REVISED RESPONSE TO REQUEST FOR ADDITIONAL INFORMATION

APR1400 Design Certification

Docket No. 52-046

RAI No.: 171-8143
SRP Section: 11.03 – Gaseous Waste Management System
Application Section: 11.03 – Gaseous Waste Management System
Date of RAI Issue: 08/25/2015

Figure 1. Schematic Diagram of GWMS

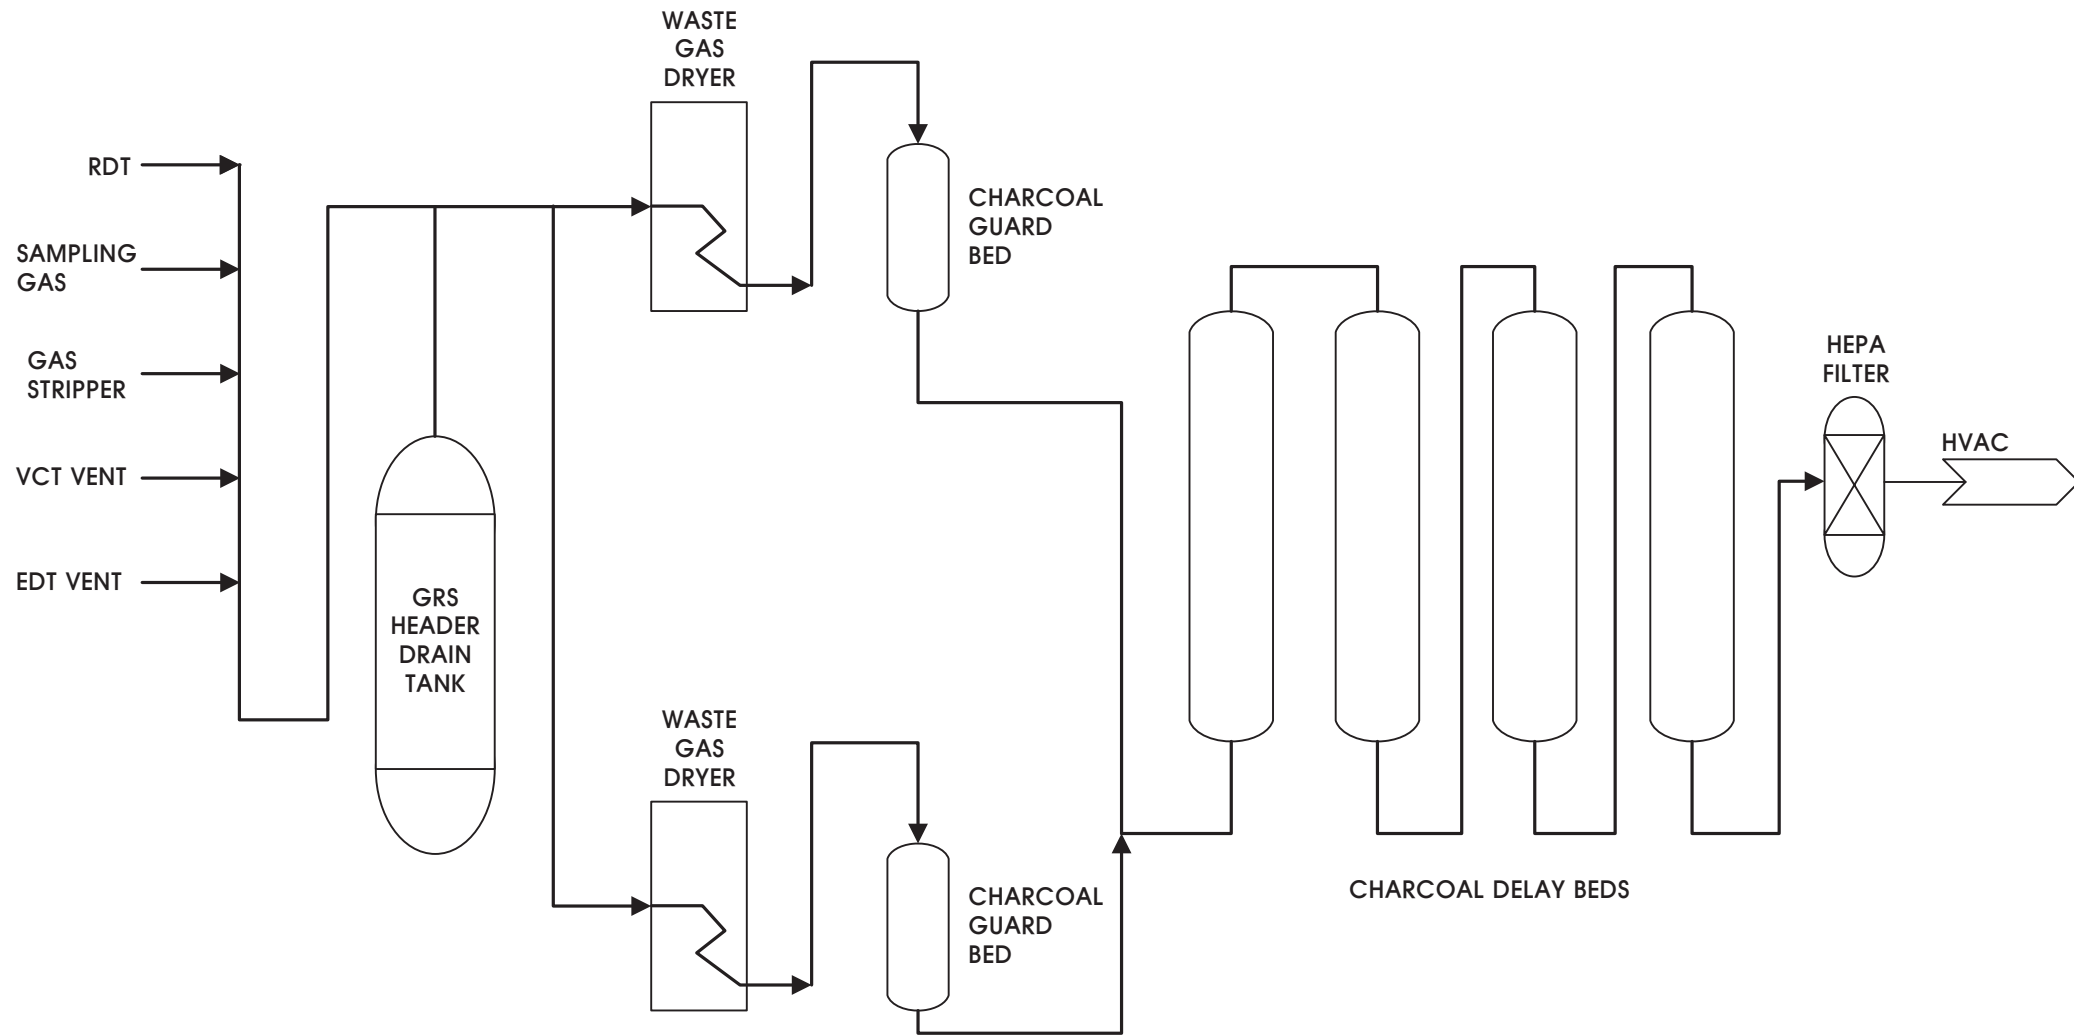
The staff reviewed DCD section 11.3.3.2 and Table 11.3-9 that show the applicants Gaseous Waste Management System Failure Doses. These doses appear to be in within BTP 11-5 guidelines, however the staff requests a calculation package to verify the results provided in Table 11.3-9, specifically:

1. BTP 11-5 describes the use of Regulatory Guide 1.109's Table B-1 for use in calculating the results of the BTP 11-5 analysis. Please verify the use of these values in Table B-1.
2. Results of NRC staff review of an equation on page 11.3-27 suggests that KHNP used FGR 12, applying the RADTRAD Computer Code, as the source for dose conversion factors. Please verify the source of the dose conversion factors.

3. The calculation package should include a description of all parameters used in the analysis to determine the results of Table 11.3-9. Please provide a detailed list of all parameters utilized to determine Table 11.3-9 results.
4. The calculation package should include a list all equations used to calculate the results of Table 11.3-9. Please provide all equations utilized for Table 11.3-9 calculations.
5. Please provide an equation or DCD reference section for all parameters found on page 11.3-27.
6. Please provide clarification to section 11.3.3.2 to describe the source of data for parameters R(i)n, R(i)a, and MF(i) and also provide the equations used to calculate the discussed variables.

The source term data provided in Table 2 are different from those used in calculating the dose values in DCD Table 11.3-9. KHNP revised the source term data to only include the release from GWMS. Therefore, DCD Table 11.3-9 will be updated to incorporate this change of the source term. Previous calculation used the total source terms from PWR-GALE Code output which is the sum of the GWMS release and the building ventilation releases. However, since this analysis only needs to consider release from the failure of waste gas system, the releases from other vents are not required to be included.

The schematic diagram of APR1400 GWMS is provided in Attachment 2 of the response.
